UNITED STATES PATENT AND TRADEMARK OFFICE

APPLICATION NO.	FILING DATE	FIRST NAMED INVENTOR	ATTORNEY DOCKET NO.	CONFIRMATION NO.
10/033,113	10/25/2001	Allan Charles Acciacca	DP-305859	7686
7590	12/09/2003		EXAMINER	
KATHRYN A. MARRA			FLANDRO, RYAN M	
DELPHI TECHNOLOGIES, INC.			ART UNIT	PAPER NUMBER
Legal Staff, Mail Code: 480-414-420			3679	
P.O. Box 5052				
Troy, MI 48007-5052			DATE MAILED: 12/09/2003

Office Action Summary	Application No.	Applicant(s)
	10/033,113	ACCIACCA, ALLAN CHARLES
	Examiner Ryan M Flandro	Art Unit 3679
<i>-- The MAILING DATE of this communication appears on the cover sheet with the correspondence address --</i>		
Period for Reply		
A SHORTENED STATUTORY PERIOD FOR REPLY IS SET TO EXPIRE 3 MONTH(S) FROM THE MAILING DATE OF THIS COMMUNICATION.		
<ul style="list-style-type: none"> - Extensions of time may be available under the provisions of 37 CFR 1.136(a). In no event, however, may a reply be timely filed after SIX (6) MONTHS from the mailing date of this communication. - If the period for reply specified above is less than thirty (30) days, a reply within the statutory minimum of thirty (30) days will be considered timely. - If NO period for reply is sp

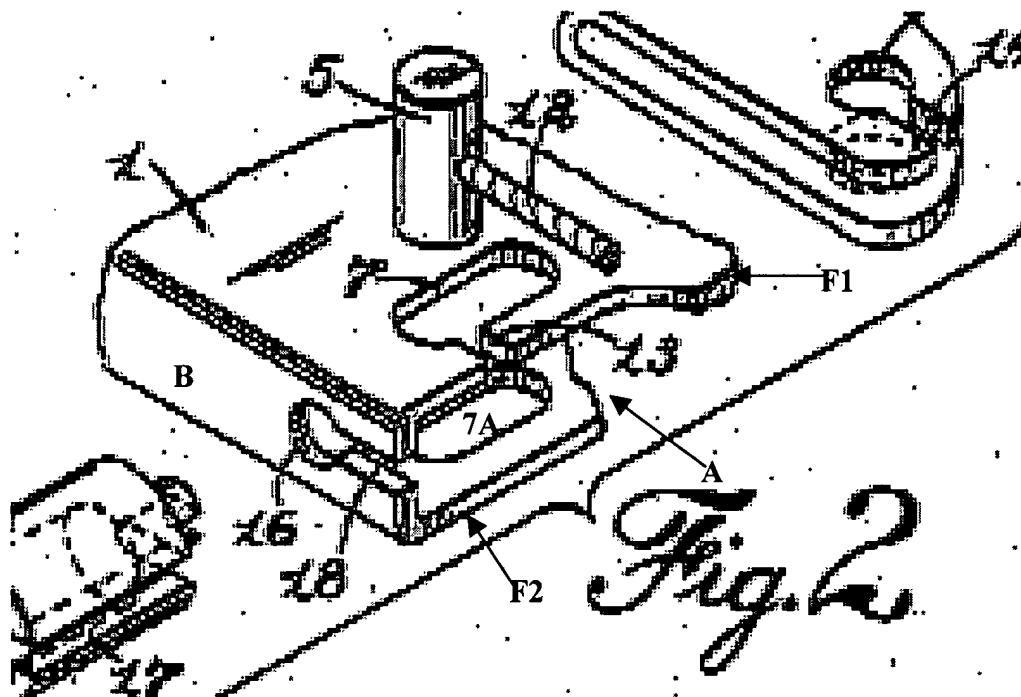
- a. Claim 1. Gleasman specifically shows a cable attachment for attaching a cable **12** to an end portion of a member **1** comprising the member **1** having an open ended loading slot **A** that extends completely across and into the end portion of the member **1** to an inner end (opposite side of surface **B**) forming separate cantilevered fingers **F1,F2**

extending across the member **1** on opposite sides of the loading slot **A**, the loading slot **A** spanning the separate fingers **F1,F2** to form openings between the fingers **F1,F2** at opposite sides of the end portion, the end portion having a retaining slot **16,18** that is transverse to the loading slot **A**, the loading slot **A** having an inner end portion (near opposite side of surface **B**) and the retaining slot **16,18** having an outer end portion **18** that overlaps the inner end portion of the loading slot **A**, the end portion having a first transition slot **7** that extends from one of the opposite sides of the end portion through one of the fingers **F1** into the inner end portion of the loading slot **A** and the overlapping outer end portion **18** of the retaining slot **16,18**, the end portion having a second transition slot **7A** that extends from another of the opposite sides of the end portion through another of the fingers **F2** into the inner end portion of the loading slot **A** and the overlapping outer end portion **18** of the retaining slot **16,18**, and the cable **12** extending through the retaining slot **16,18** and having a ferrule **5** that engages a surface of the end portion adjacent the retaining slot **16,18** for moving the member **1**, the cable **12** being moveable axially in the retaining slot **16,18** to form a lost motion attachment with the end portion of the member **1** (see annotated figure 2 below; columns 1 and 2).

b. Claim 2. Gleasman, as applied to claim 1 above, also shows the cable **12** loaded into the retaining slot **16,18** through the loading slot **A** and the first and the second transition slots **7,7A** (see annotated figure 2 above).

c. Claim 3. Gleasman also shows the second transition slot **7A** is coplanar with the first transition slot **7** (see annotated figure 2 above – plane normal to surfaces **F1 and B**).

d. Claim 4. Gleasman also shows the retaining slot **16,18** as being linear (see annotated figure 2 above).

e. Claim 5. Gleasman also shows that the retaining slot **16,18** being shaped to inhibit escape of the cable **12** transverse to its axis (see annotated figure 2 above).

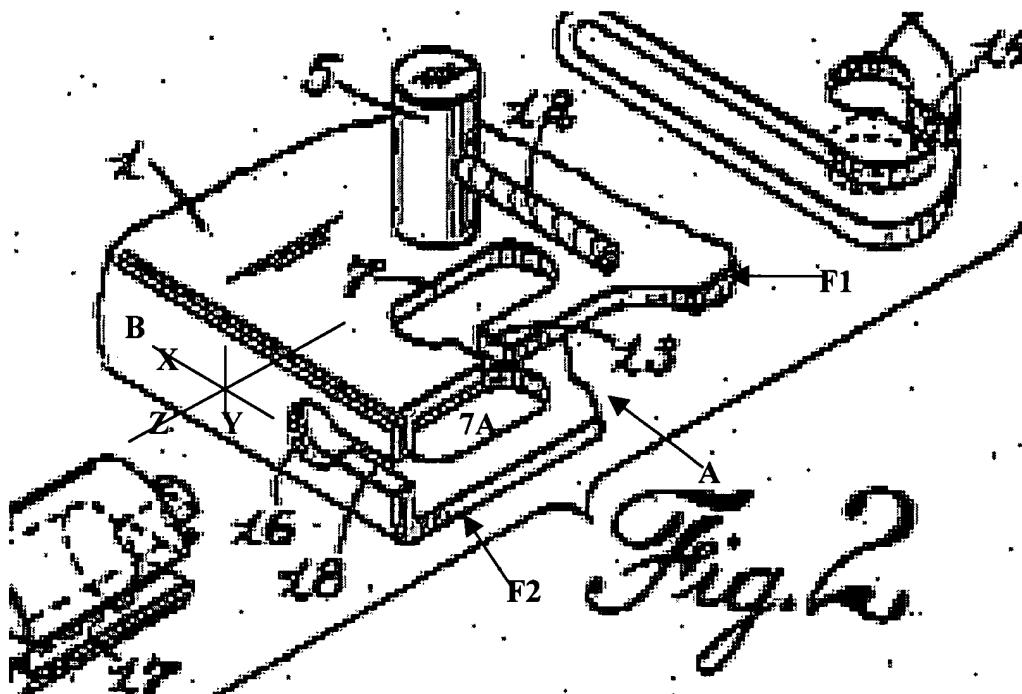
- b. More specifically, the Examiner has read the Gleasman reference such that any "slot" shown therein extends indefinitely in a direction transverse to a defined planar boundary of a given slot. For example (see figure 2 as modified below), with respect to the retaining slot **16,18**, the Examiner understands this slot to extend in two directions (X,Y) in the plane of surface **B** as well as indefinitely in a direction (Z) transverse to the plane of surface **B** such that the slot can be said to "overlap" with an inner end portion of space **A** between the plates **F1,F2**. In the same respect, slots **7** and **7A** are interpreted to extend in two directions (Z,X) along the surfaces of plates **F1 and F2** as well as indefinitely in a direction (Y) transverse to the surfaces of plates **F1 and F2** such that the slots **7 and 7A** can be said to "overlap" with one another as well as with retaining slot **16,18** and space **A**. In essence, each "slot" has boundaries defined in one plane but is understood to extend indefinitely in directions transverse to that plane. The Examiner respectfully asserts that such an interpretation of Gleasman overcomes Applicant's arguments as to the subject matter recited in paragraphs b-d of claim 1 as denoted in pages 8-9 of the response (paper no. 6).

- e. Regarding claim 3, Applicant argues that slots **7 and 7A** are not coplanar. The modified version of figure 2 above shows, however, that slots **7 and 7A** both lie in the (Y,X) and (Y,Z) planes. Thus, this argument is not persuasive.

- f. Regarding claim 4, Applicant argues that slot **16,18** is not linear as recited in the claim. This is not persuasive. Portions **16 and 18** of the slot lie in a straight line and, thus, the slot is linear. This meets the claimed limitation. The claim does not recite that the walls of the slot are flat or linear, which is what Applicant seems to be implying. The shape of portion **16** is irrelevant in view of the claim as written.

- h. Regarding claim 8, Applicant argues that the retaining slot **16,18** is not perpendicular to loading slot **A**. In view of the understanding of Gleasman expressed above, the Examiner maintains that slot **16,18** can be considered perpendicular to slot **A**. Specifically, slot **16,18** extending in the **Z** direction is perpendicular to slot **A** which extends, for example, in the **X** direction. Thus, this argument is not persuasive.
